NOTICE OF ADDENDUM ADDENDUM NO. 1

CONTRACT NO. 8144 WINGRA PARK SHORELINE CITY OF MADISON WISCONSIN

The plan set, specifications, and proposal pages have been modified to accommodate elevating the proposed asphalt path approximately 4 inches from the previously proposed elevations. This alters grades adjacent to the path. The asphalt surface has been changed from HMA Pavement Type E-0.3 to Porous Pavement, and limestone shoulders have been added. Raising the path will require removal and replacement of the concrete pad at Station 21+35.00. An H-Inlet has been added to drain a low-point created behind the path.

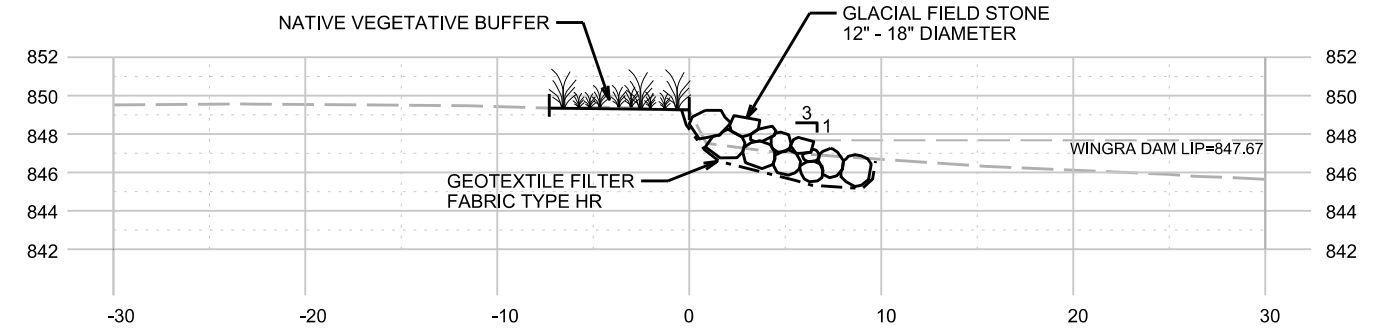
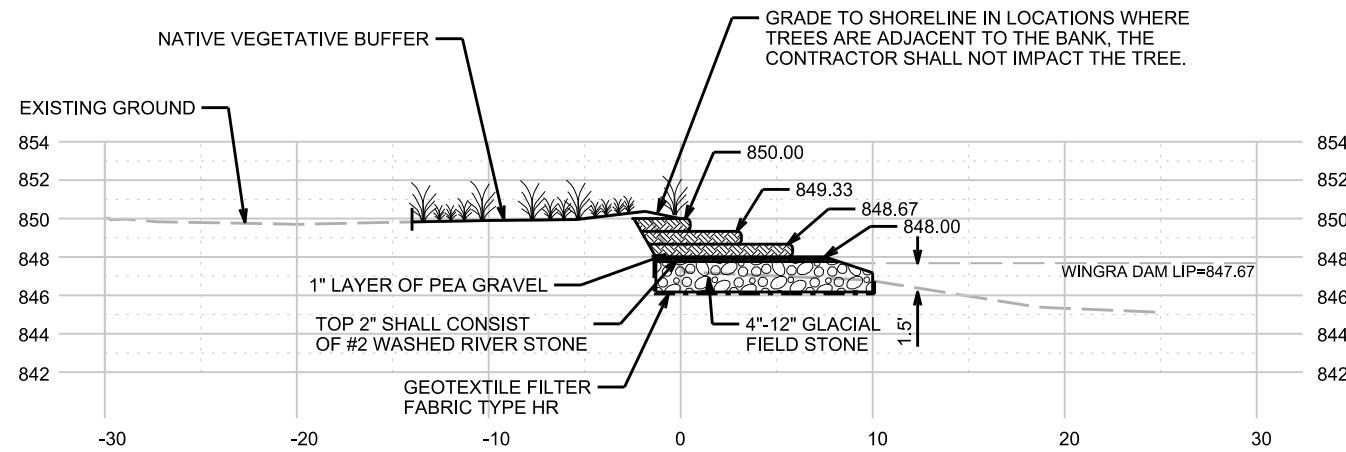
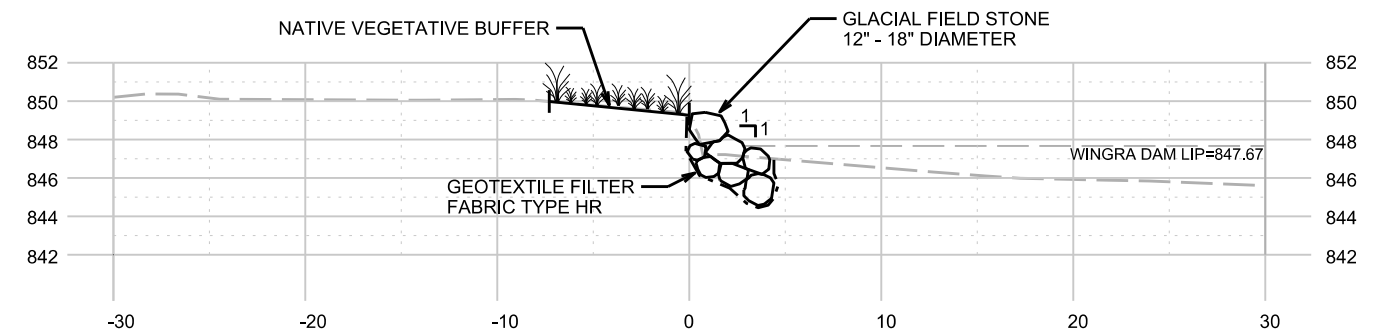
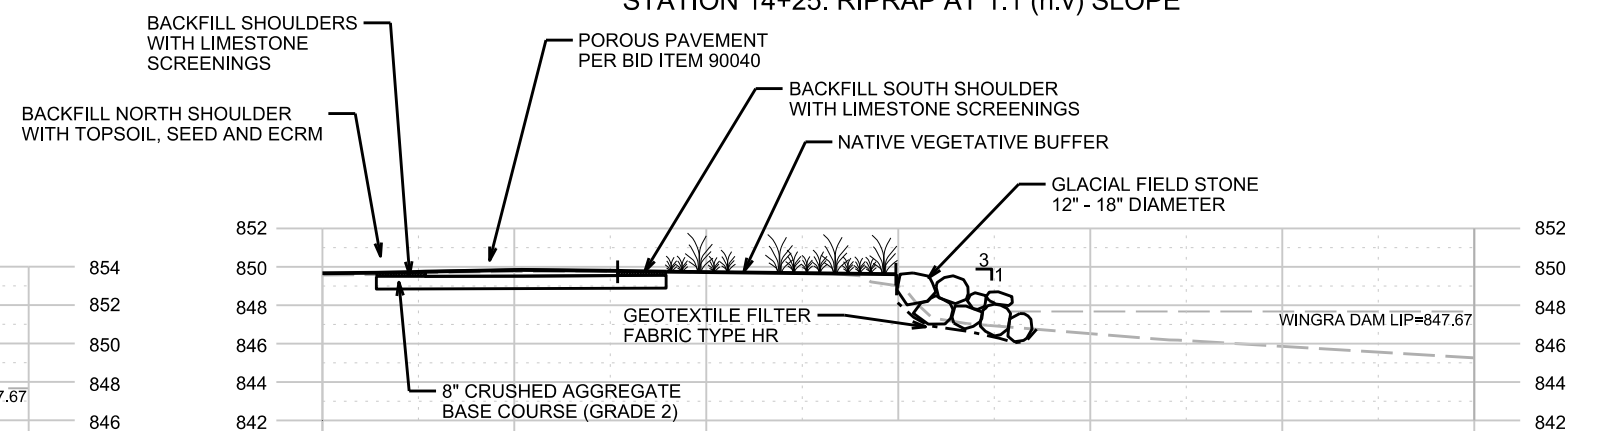
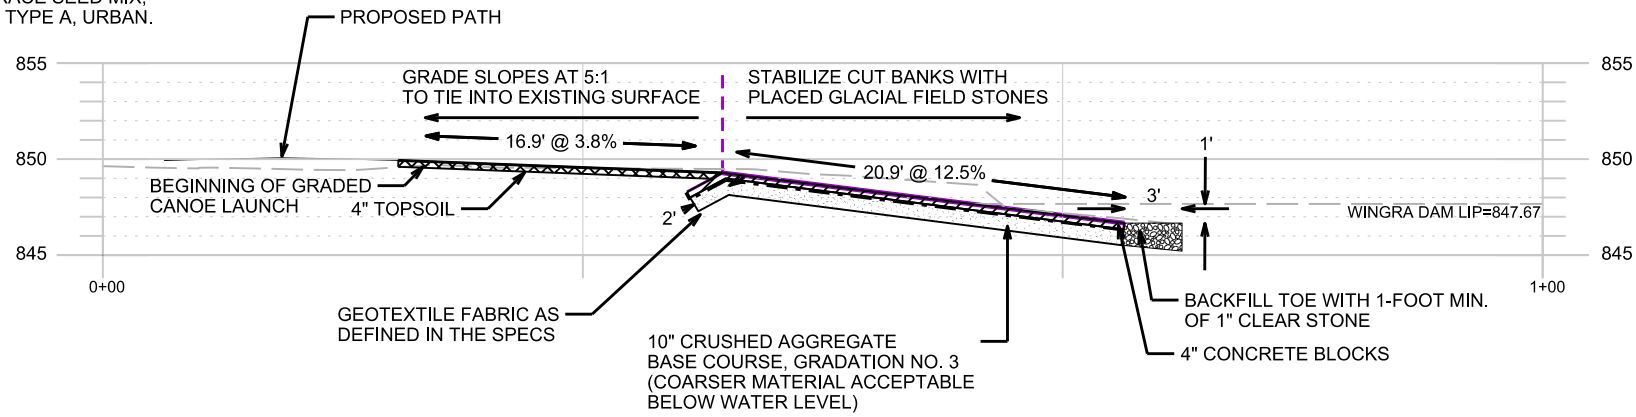
- D-1: Typical cross-sections showing the asphalt path have been revised.
- D-2: Canoe launch grades have been altered to tie into the revised asphalt path elevations.
- P-1: Grading limits and proposed topographic lines have been altered to show the revised bike asphalt path grading.

PLAN AND PROFILE

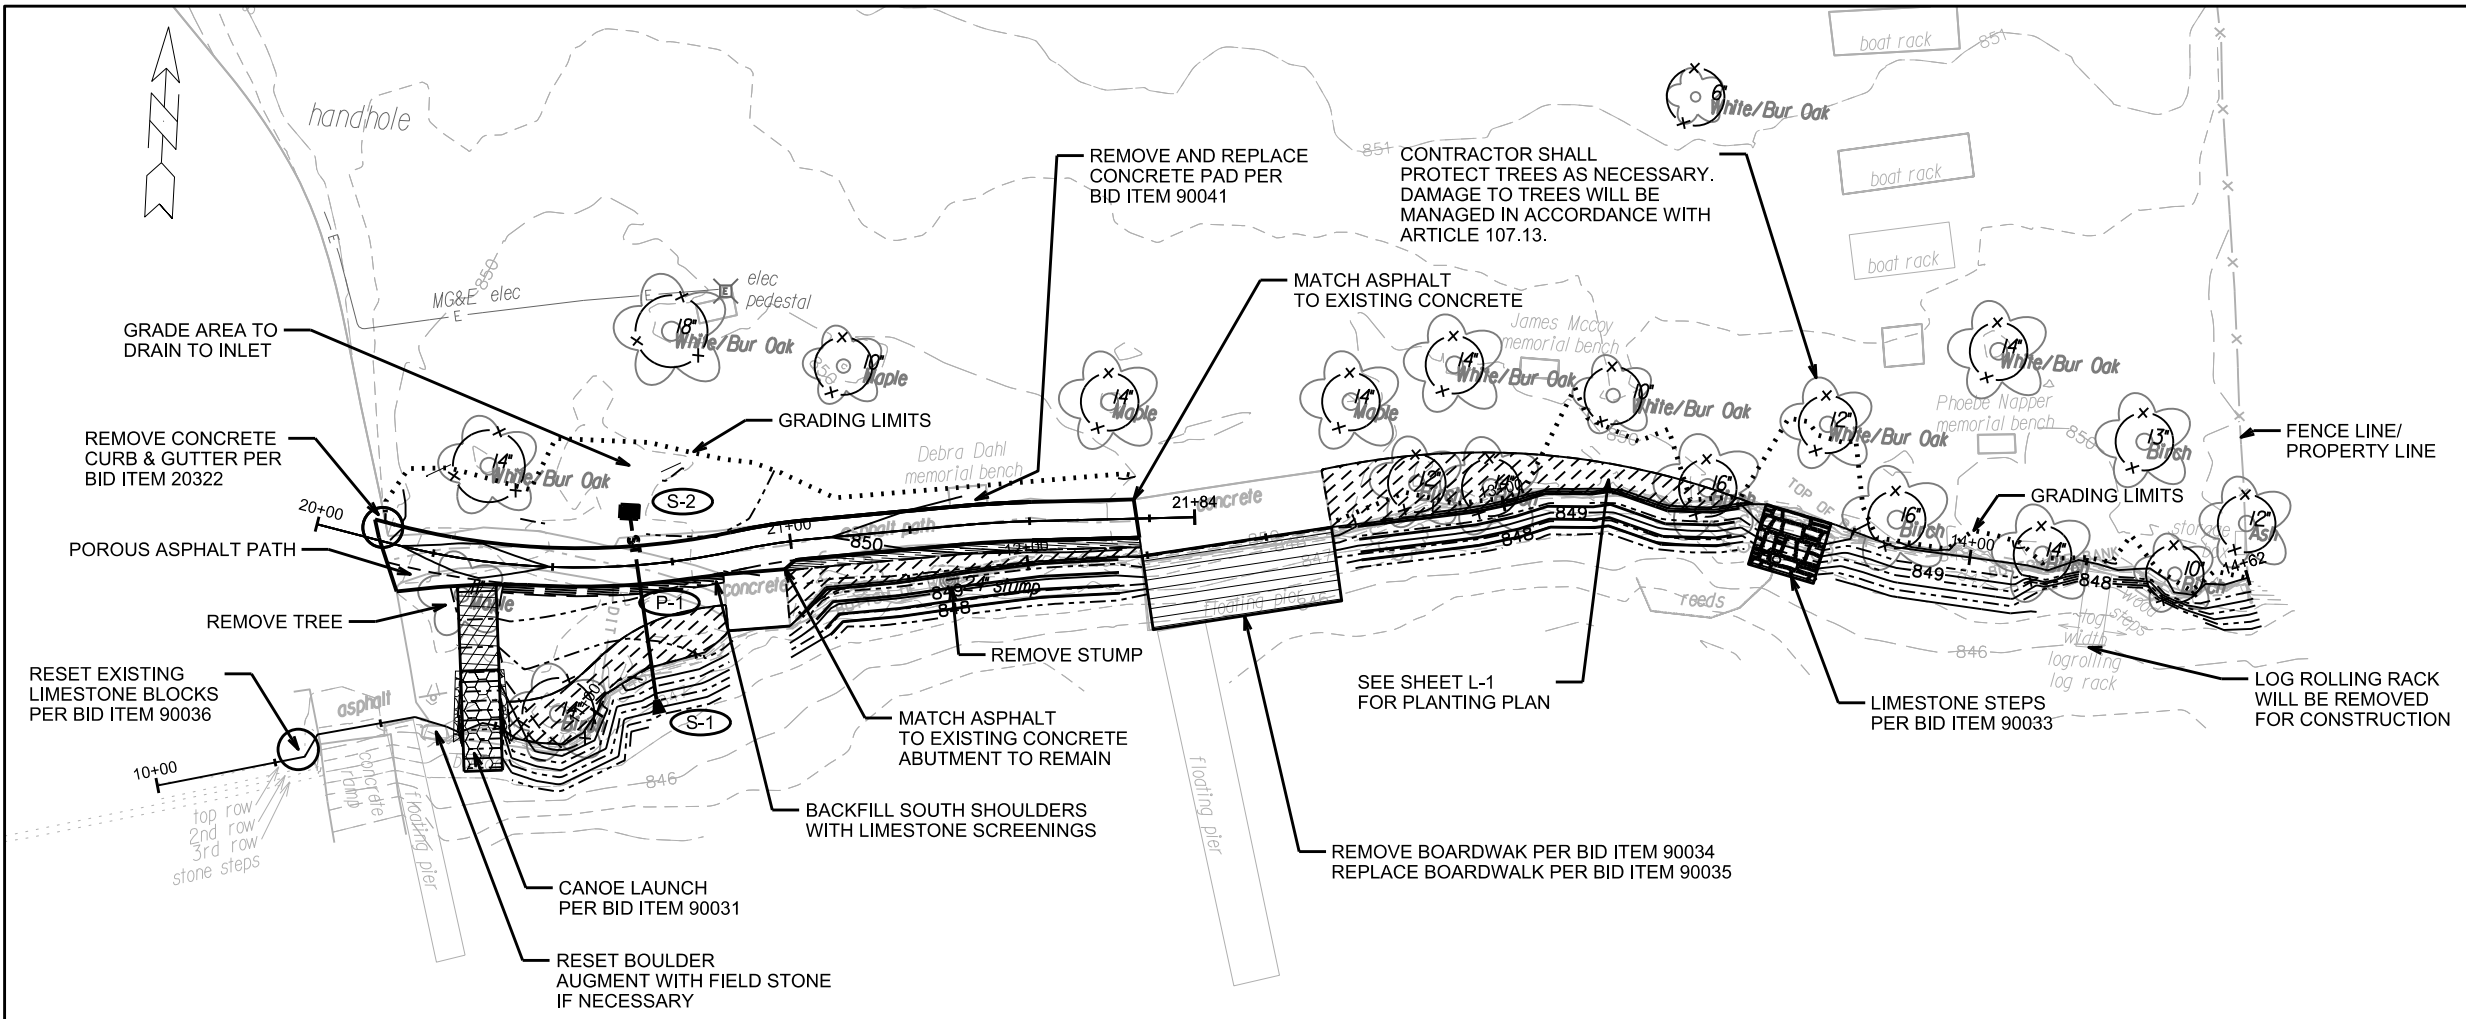
- P-2: Grading limits have been altered to show the revised bike path limits.
- X-1 through X-7: Grades have changed slightly to accommodate elevated asphalt path.
